City of Beaumont Wastewater Treatment Plant Salt Mitigation Upgrade Project Change Order No. 15

April 14, 2020

Contractor: W.M. Lyles Co.	Original Contract: \$ 53,312,000.00	Calendar Days: 820	Comp. Date: 1/26/2021
Project Name: Wastewater Treatment Plant Salt Mitigation Upgrade Project	Previous Approved Changes: \$1,640,717.91	95	5/1/2021
Contract No.: C18-80	This Change: Amount \$79,713.39	0	
CO Number: 15	Revised Contract: \$55,032,431.30	915	5/1/2021
	Previous Phase 1 Completion Date		4/26/2020
	Revised Phase 1 Completion Date		4/26/2020

CLARIFICATION 17R1

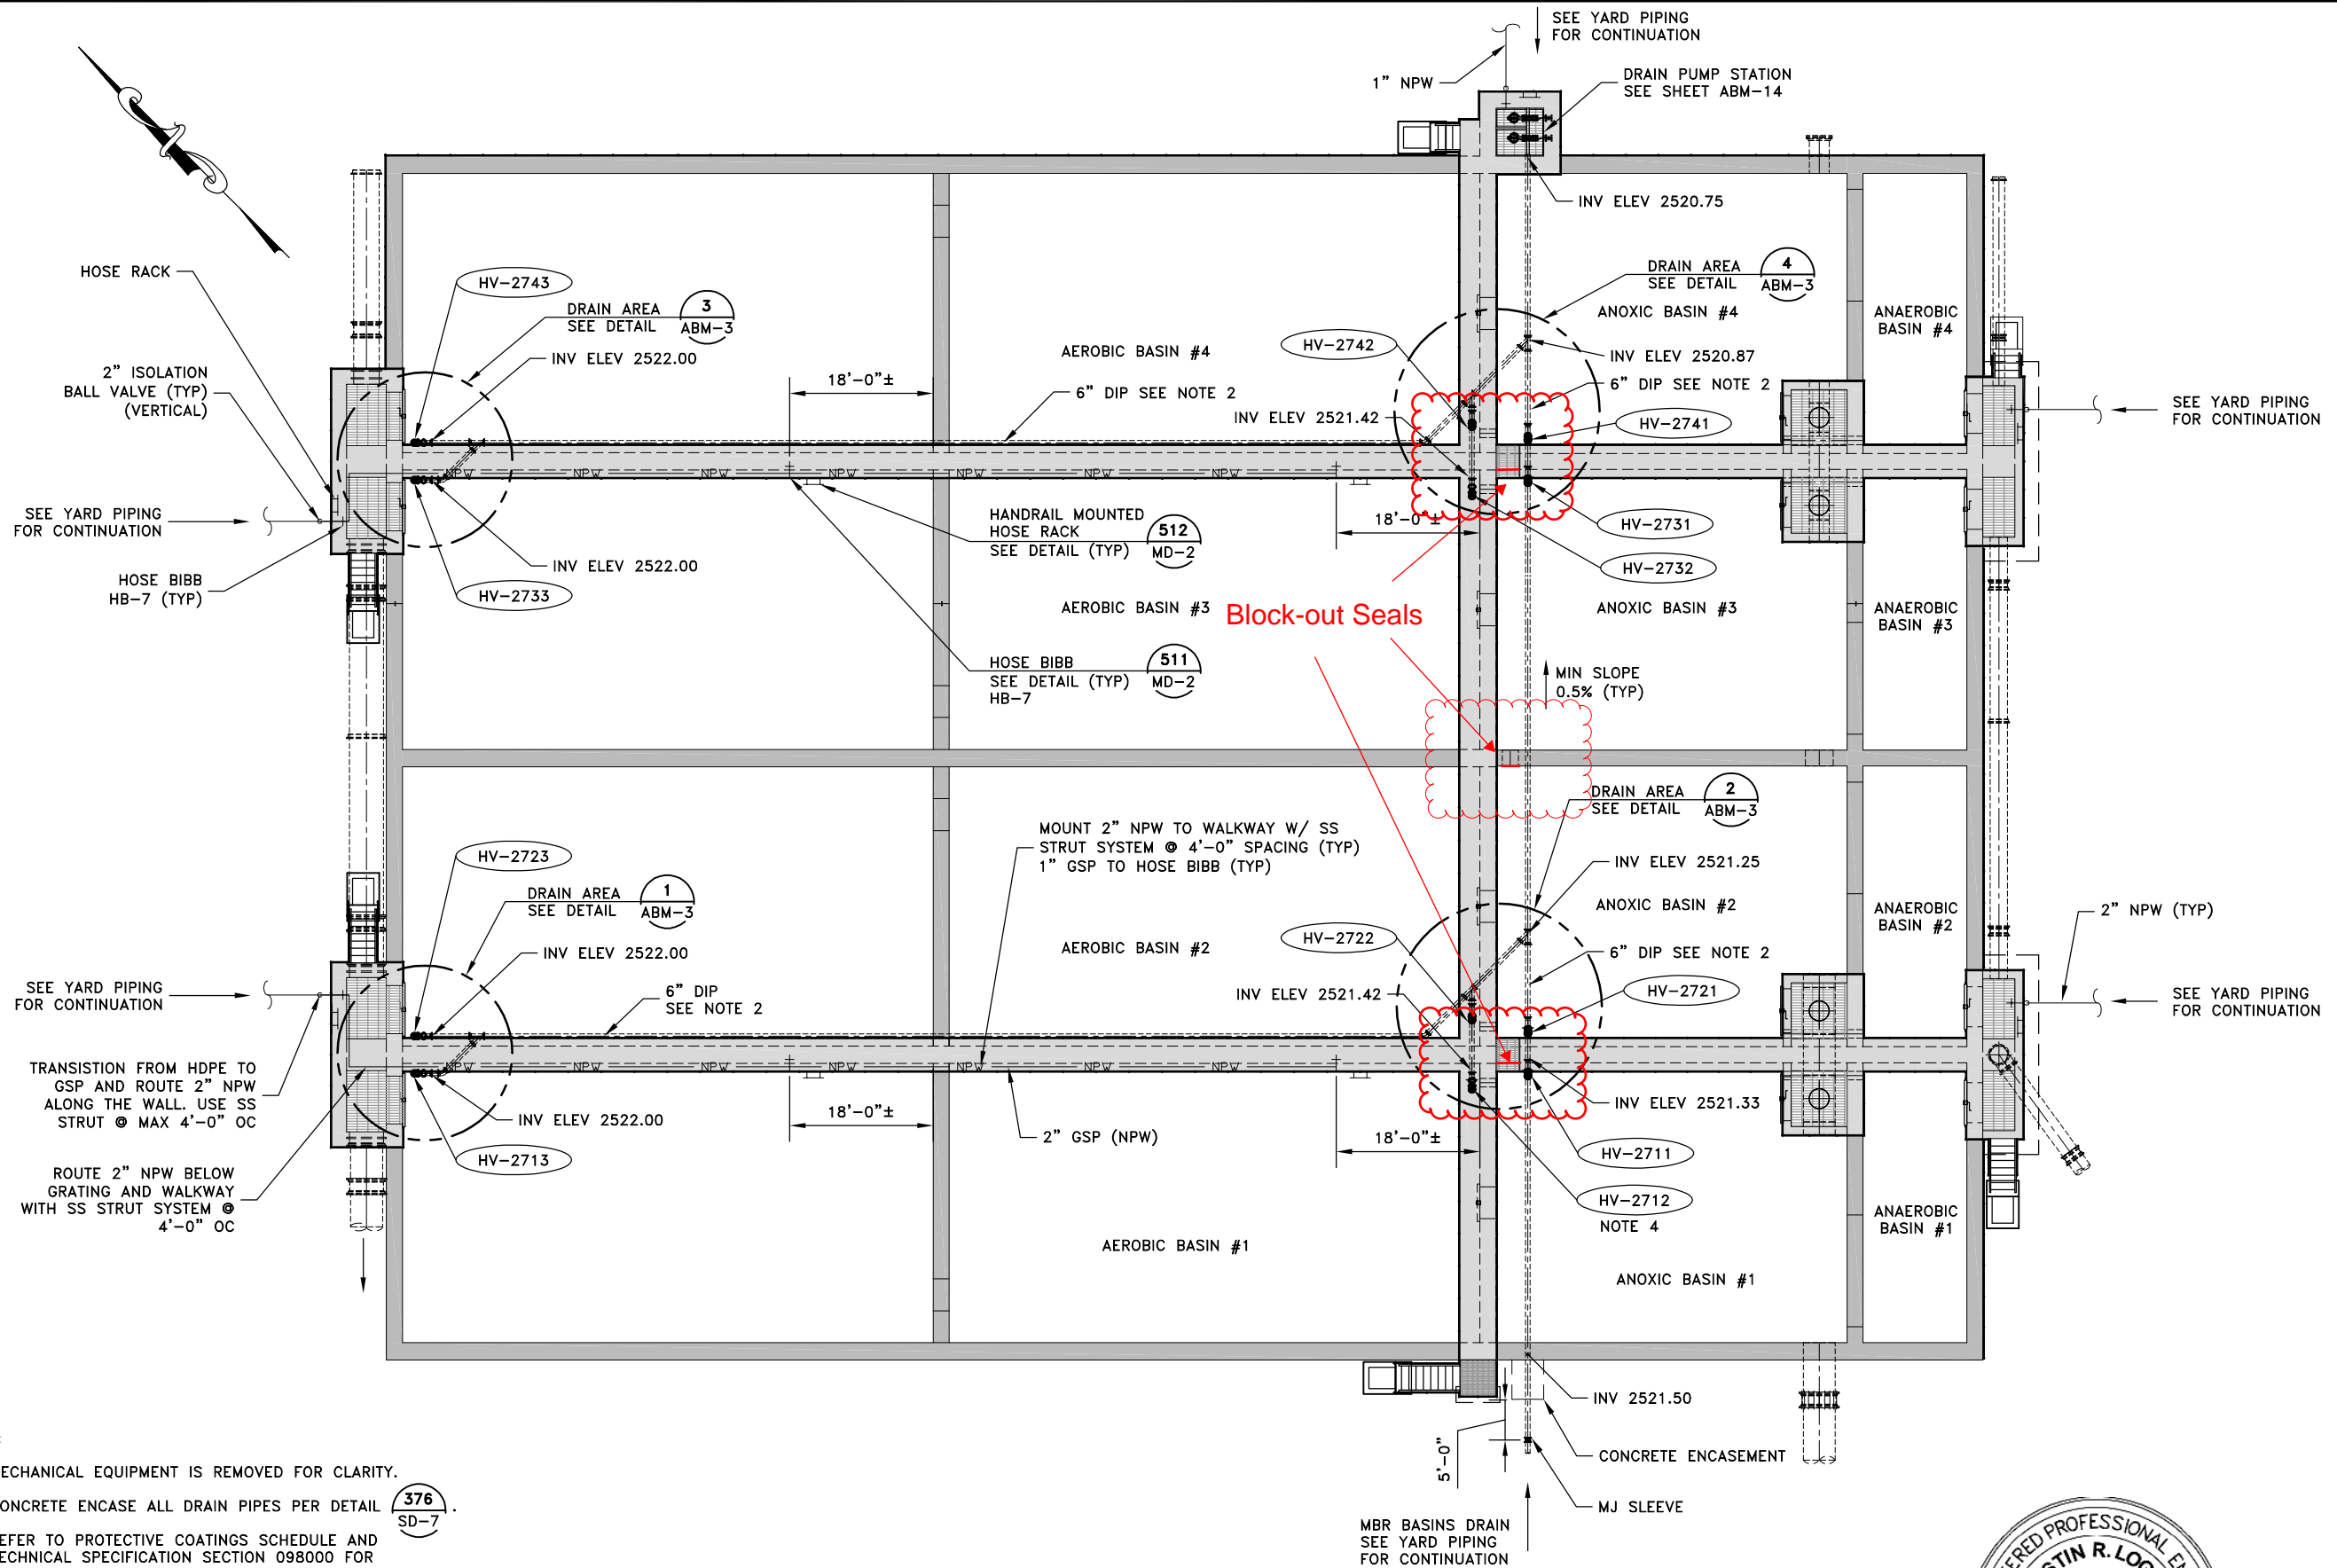
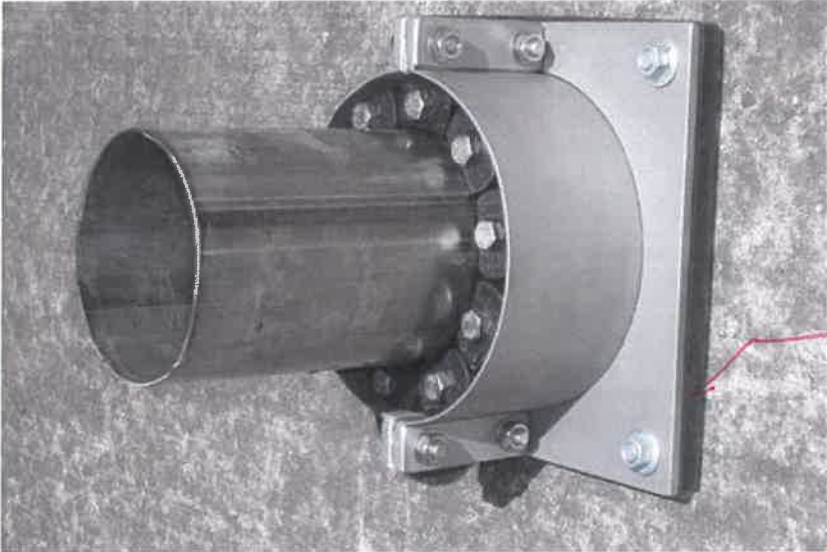
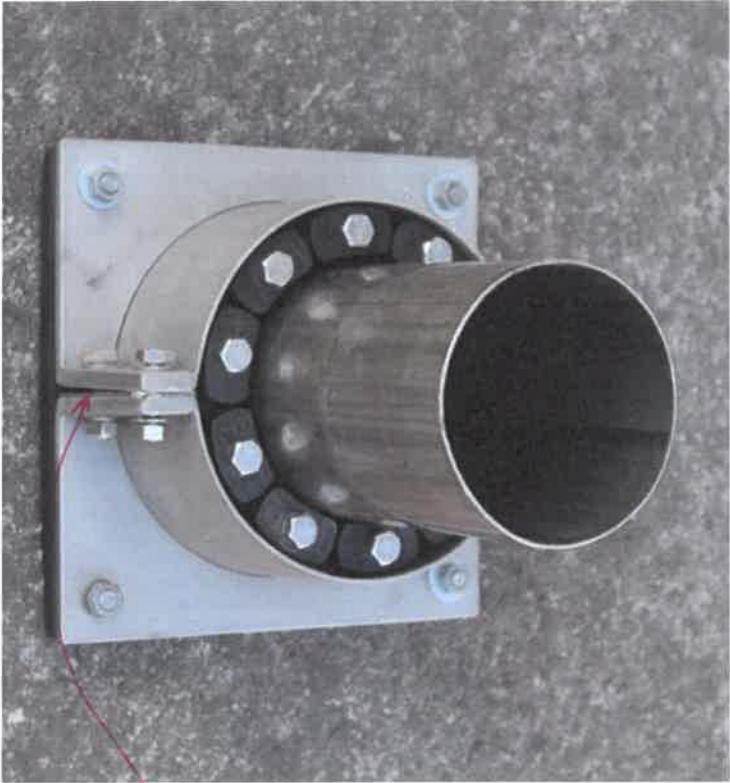
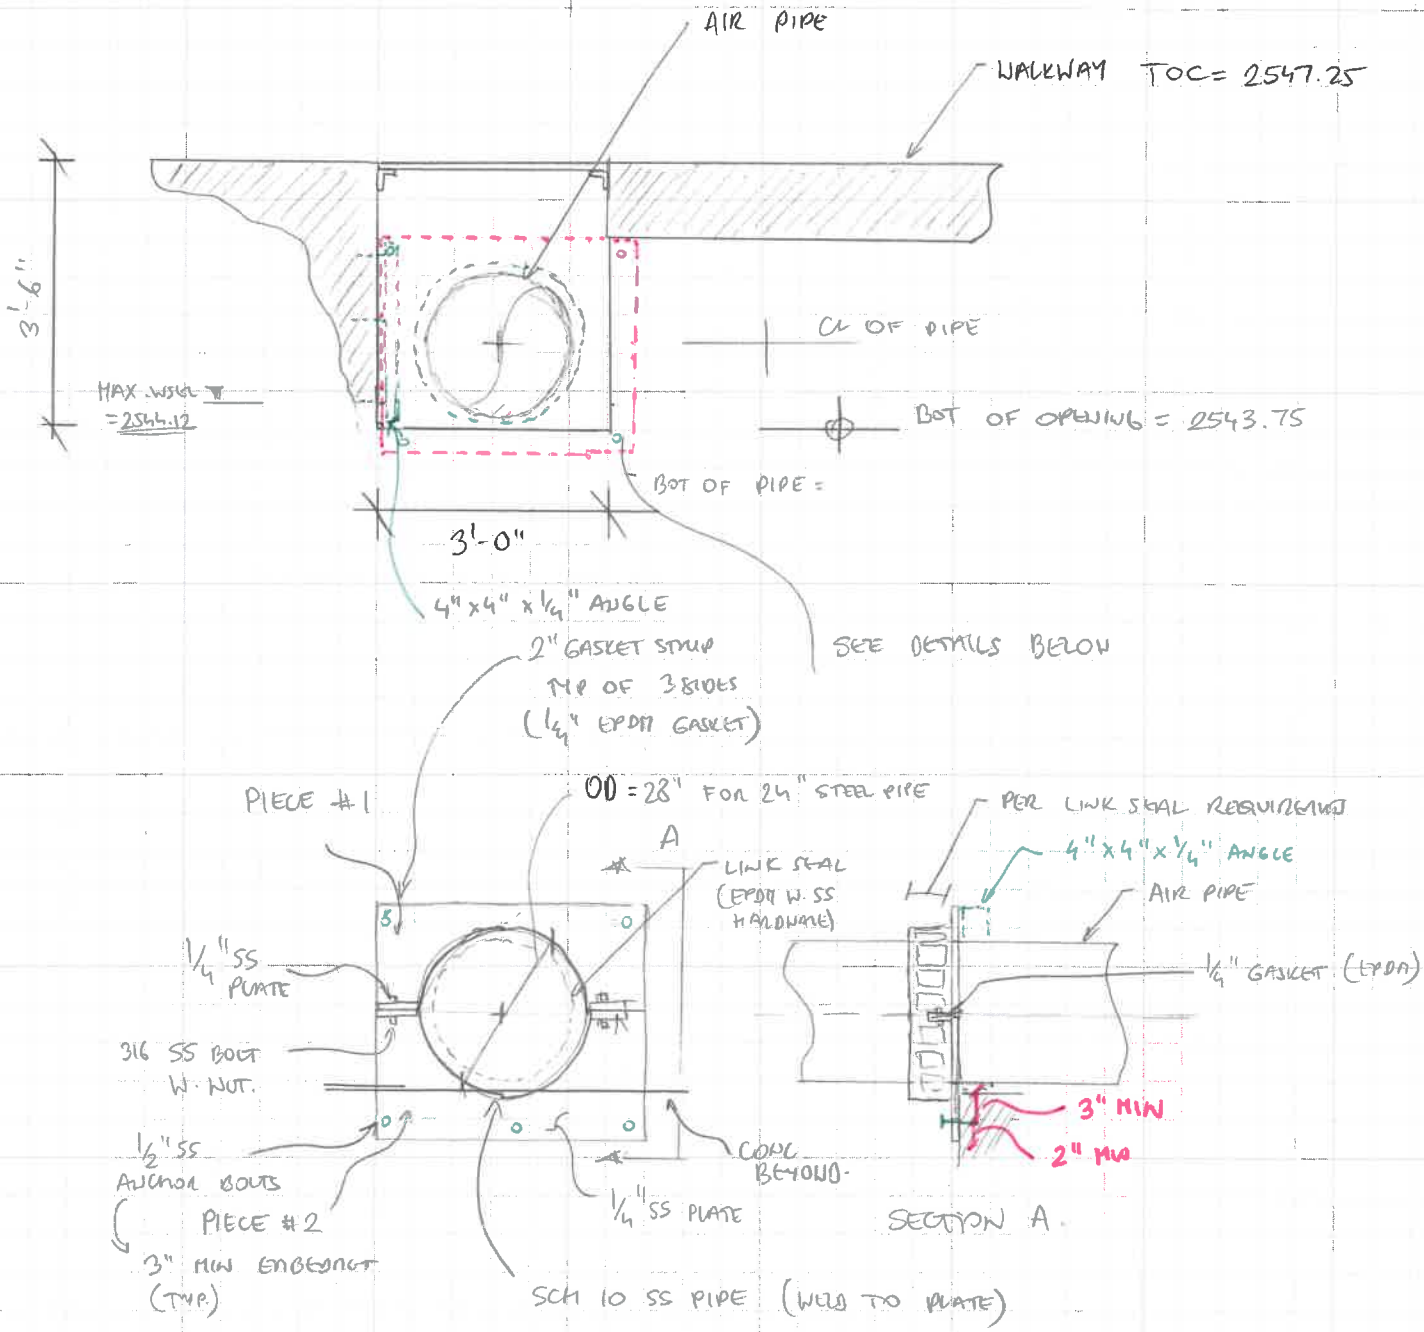
PCO-32	
Design Adjustment: WML COP-037	Aeration Basin Air Piping Block-outs [DCM-11]
<p><u>Reason for Design Changes:</u></p> <p>Design Engineer Requested Change. At the high-water level inside new aeration basins 1 through 4 the 20-inch aeration piping passes through the separation walls of each basin. The invert of the block out for the piping system is below the high-water level, which will cause unwanted cross flow of MLSS into adjacent basins.</p> <p><u>Design and Scope Changes:</u></p> <ul style="list-style-type: none">• The aeration basin wall separating basins #2 and #3 should have a block-out for air pipe like the block-out called out and detailed in section G on drawing ABS-6. Following the air pipe installation, the block-outs will need to be sealed to provide a water-proof separation between basins. The detail for this closure is shown in CLAR-17R1 and shall be provided of pipe through wall locations between basins 1 & 2, 2 & 3 and 3 & 4. <p><u>Cost Impact:</u></p> <p>MWHC has evaluated the extra cost proposal by the Contractor. MWHC recommends a contract cost increase of \$14,550.23 to be executed in a change order for the procurement and installation of additional structural/mechanical materials.</p>

I'm sorry, I gave you the wrong dimension. It was supposed to be 24" OD pipe in a 27.25" ID sleeve. Please requote.
Thanks,

SHEET 30 OF 172
NI-01

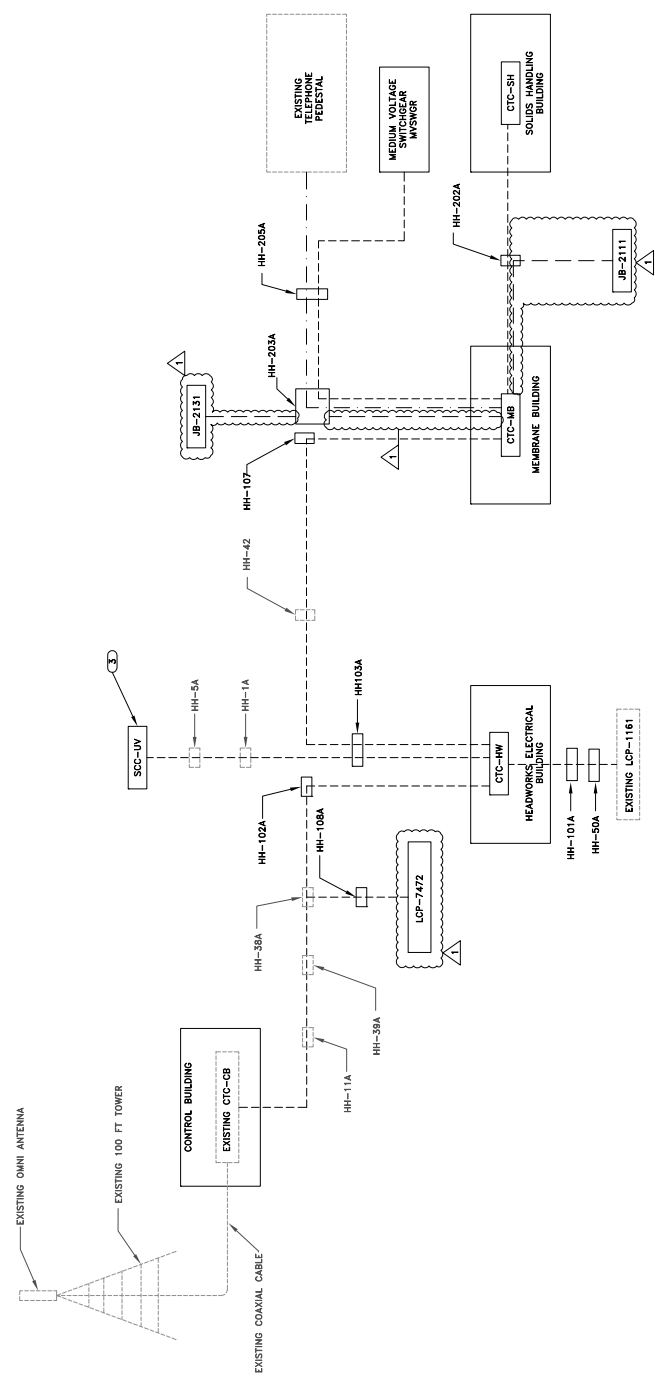
To (Construction Manager): Stantec Attention: Charles Reynolds Phone: 702-497-8024 Email: Charles.w.reynolds@stantec.com	
From (Engineer): SKM Engineering Attention: Lindsey Stevens Phone: 801-677-0011 Email: lindsey.stevens@skmeng.com	
Subject: Modifications to HACH Instrumentation	Location: Throughout the Facility
Reference Documents: Drawing Nos. NI-01, NI-02, NI-04, NI-04A, NI-07, I-19, I-24, I-25, I-33, I-34, GE-08, SE-03, LE-07, LE-13, CE-07, CE-08, CE-09, CE-20	
CLARIFICATION	
Note the following:	
The HACH transmitters will all be model sc4200, as requested by the owner. As a result, several changes have been made to the network in the facility and the communication conduits required.	
NI-01 Communication wiring (CAT6 Shielded) has been added between CTC-MB and HH-203A, as well as CTC-MB and HH-202A. LCP-7410 has been replaced by LCP-7472, which shall house AIT-7472 the pH/chlorine analyzer at the recycled water lift station. CAT6 lines have been added from HH-203A to JB-2131 and HH-202A to JB-2111.

NI-04
SHEET 33 OF 172

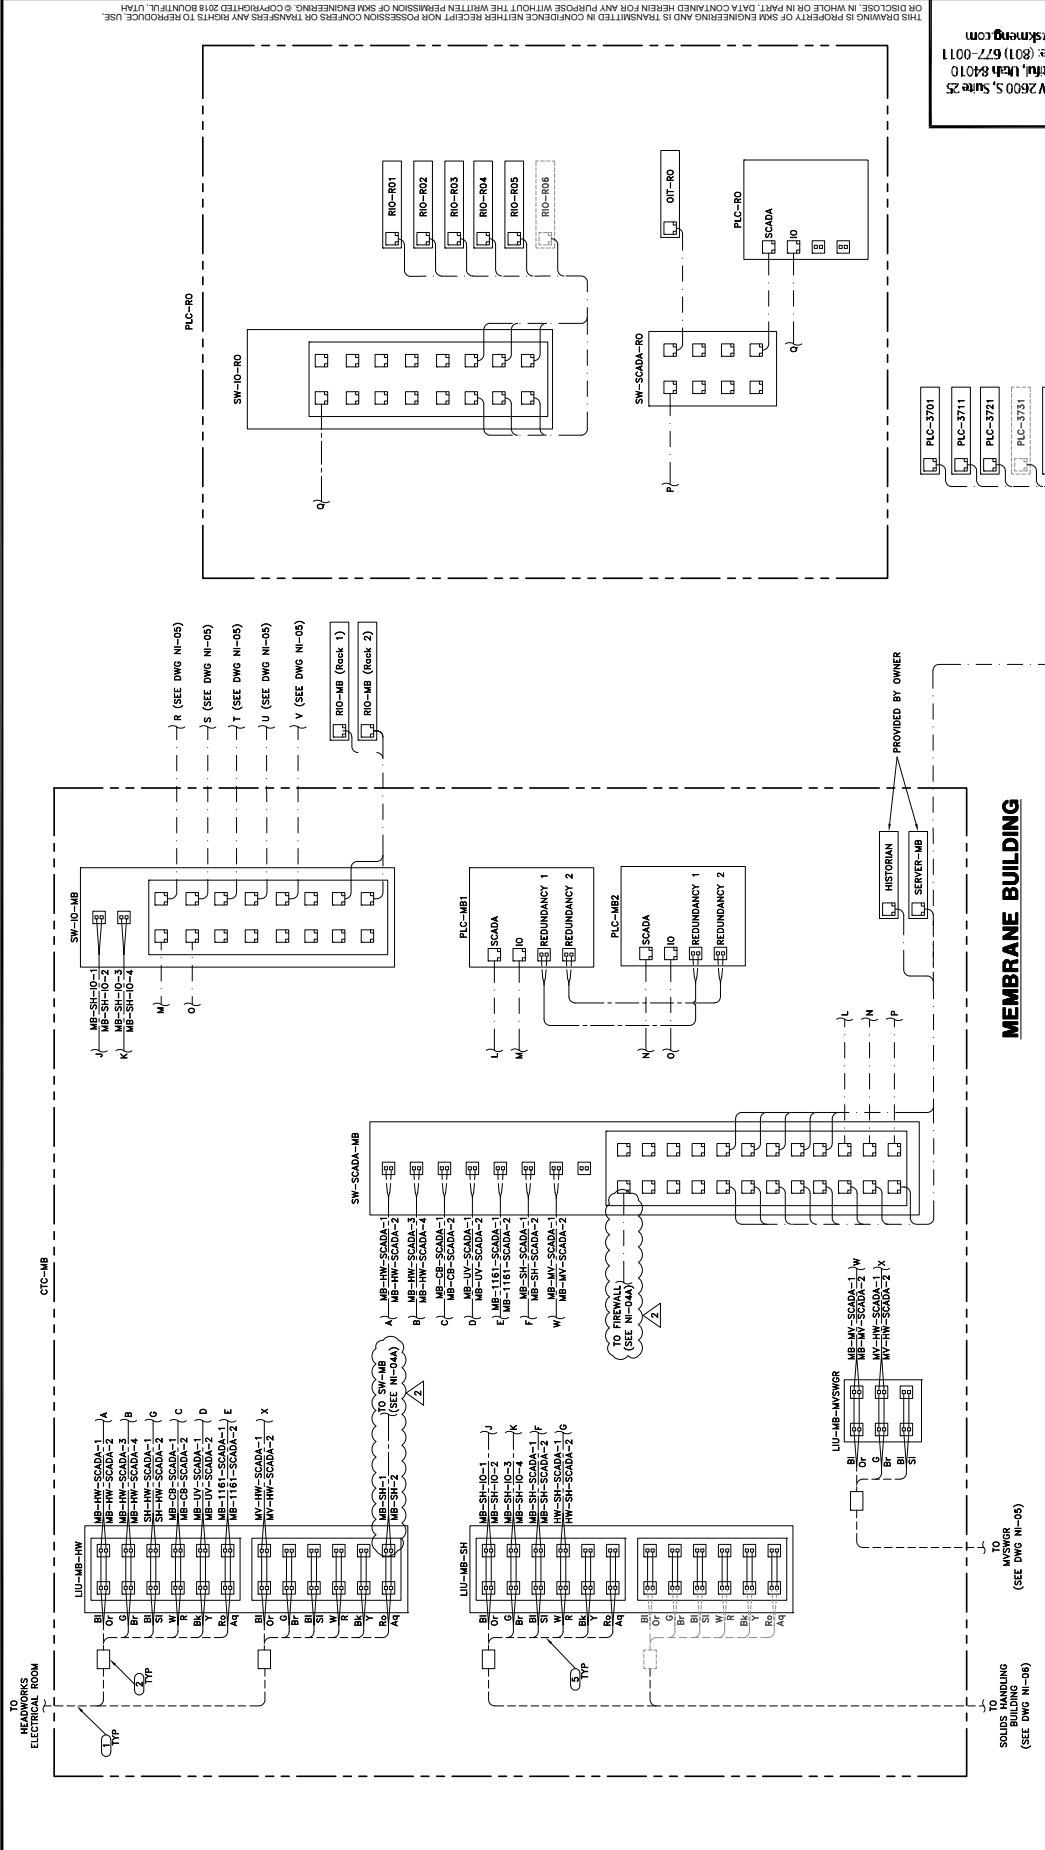
NI-02 The local interface unit LIU-HW-7410 has been removed, and LIU-HW-7472 has been added to provide communications from LIU-HW-MB to LCP-7472.	
NI-04 and NI-04A Sheet NI-04A has been added to show communication to HACH instruments at the anoxic/aeration basins, brine lines and in the MBR building. Communication wires have been added at LIU-MB-HW and for the firewall at SW-SCADA-MB.	
NI-07 Networking information for AIT-7472 has been added.	
I-19 Networking labels at CTC-HW have been updated and now include LIU-HW-7472.	
I-24 Networking labels at CTC-MB have been updated and now include LIU-MB-4602 and SW-MB.	
I-25 Connections for SW-MB and the associated firewall have been added.	
I-33 and I-34 The wiring diagram and panel drawings have been added for LCP-4602. Sheet I-34 also shows the layout for LCP-7472.	
GE-08 and LE-07 The anoxic/ aeration basin junction boxes now have wireless access points as shown in the updated detail on GE-08, at the locations shown on LE-07.
